SERVICE INFORMATION NO. SI D4-091/1

EASA EAD No. 2008-0027-E

Thielert Service Bulletin TM TAE 125-1005 P1 Bracket HP Line HPP-Fuel Rail, Rev. 1

<u>Technische Mitteilung Nr. / Datum:</u>	TM TAE 125-1005 P1, Rev. 1 / 11.02.2008
<u>Service Bulletin No. / Date:</u>	TM TAE 125-1005 P1, Rev. 1 / February 11, 2008
<u>Betrifft:</u>	Installation Halter Kraftstoffhochdruckleitung
<u>Subject:</u>	Installation of Bracket High-Pressure Fuel Line
<u>Betroffenes Luftfahrtgerät:</u>	TAE 125-02-99 (CENTURION 2.0)
<u>Type affected:</u>	TAE 125-02-99 (CENTURION 2.0)
<u>Betroffene Geräte-Nr.:</u>	Motorseriennummern 02-02-1500 bis 02-02-2279
<u>Models affected:</u>	Engine Serial Number 02-02-1500 to 02-02-2279
<u>Einstufung:</u>	Kategorie P1 – Sicherheit
<u>Classification:</u>	Category P1 – Safety
<u>Ausführung bis:</u>	Gesamtmotorlaufzeit unter 20 Std.: Maßnahmen sind vor Erreichen einer Gesamtmotorlaufzeit von 30 Std. oder mit der nächsten Inspektion durchzuführen, maßgebend ist das ersteintreffende Ereignis. Gesamtmotorlaufzeit über 20 Std.: Maßnahmen sind innerhalb der nächsten 10 Flugstunden oder mit der nächsten Inspektion durchzuführen, maßgebend ist das ersteintreffende Ereignis.

Bild 1 / Fig. 1

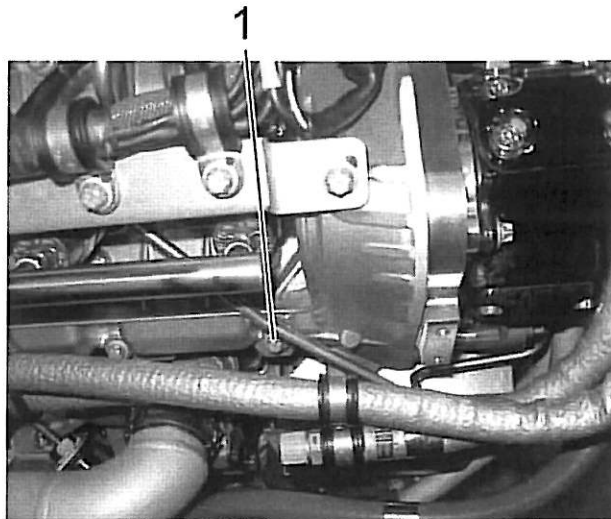
1. Die Schraube am Ventildeckel demontieren. Siehe Bild 1.
2. Den Abstandshalter montieren. Siehe Bild 3.

1. Detach the screw of the cylinder head cover. See Fig. 1.
2. Attach the spacer to the cylinder head cover. See Fig. 3.

Bild 2 / Fig. 2

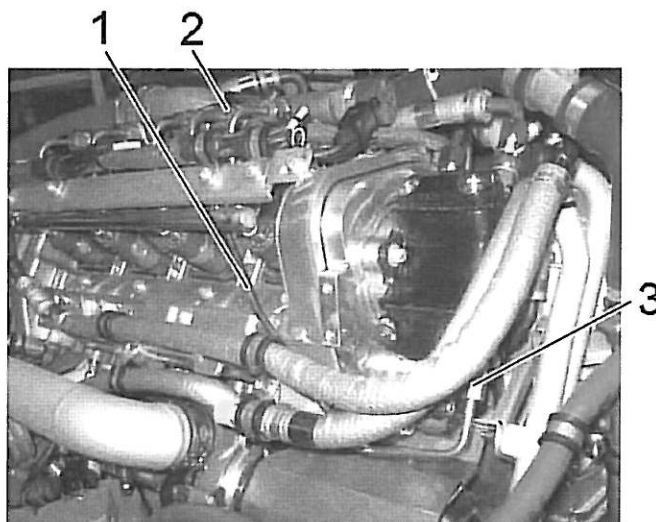
3. Die Kraftstoffhochdruckleitung demontieren. Siehe Bild 2.

4. Die neue Kraftstoffhochdruckleitung montieren. Siehe Bild 2.

9. Die Überwurfmutter der Kraftstoffhochdruckleitung festziehen. Siehe Bild 2.

Überwurfmutter Hochdruckpumpe (SW14): 22 Nm

Überwurfmutter Fuel Rail (SW18): 27 Nm

3. Remove the high-pressure fuel line. See Fig. 2.

9. Tighten the union nuts of the high-pressure fuel line. See Fig. 2.

Union nut high-pressure pump (wrench size 14mm): 22 Nm

Union nut fuel rail (wrench size 18mm): 27 Nm

Bild 3 / Fig. 3

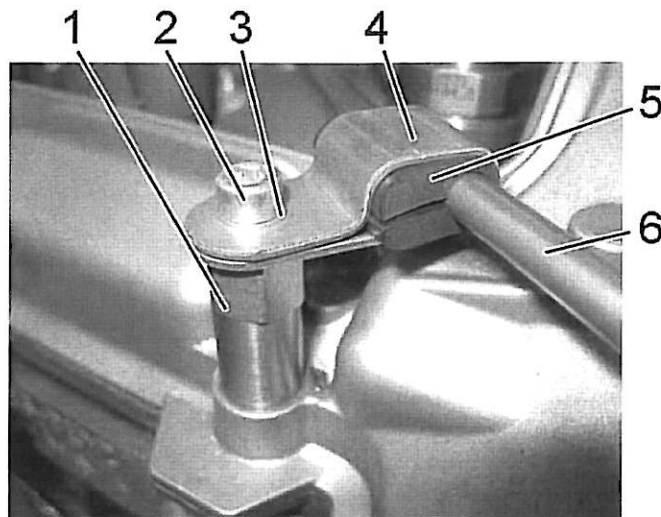
5. Den Halter und die Beilage an die Kraftstoffhochdruckleitung montieren. Siehe Bild 3.

6. Den Halter mit einer Schraube und einer Scheibe an den Abstandshalter montieren. Siehe Bild 3.

8. Die Schraube des Halters festziehen. Siehe Bild 3.

7 Nm

5. Attach the fastener and the insert to the high-pressure fuel line. See Fig 3.
6. Attach the fastener to the spacer using one bolt and one washer. See Fig. 3.

8. Tighten the screw of the fastener. See Fig. 3.

7 Nm
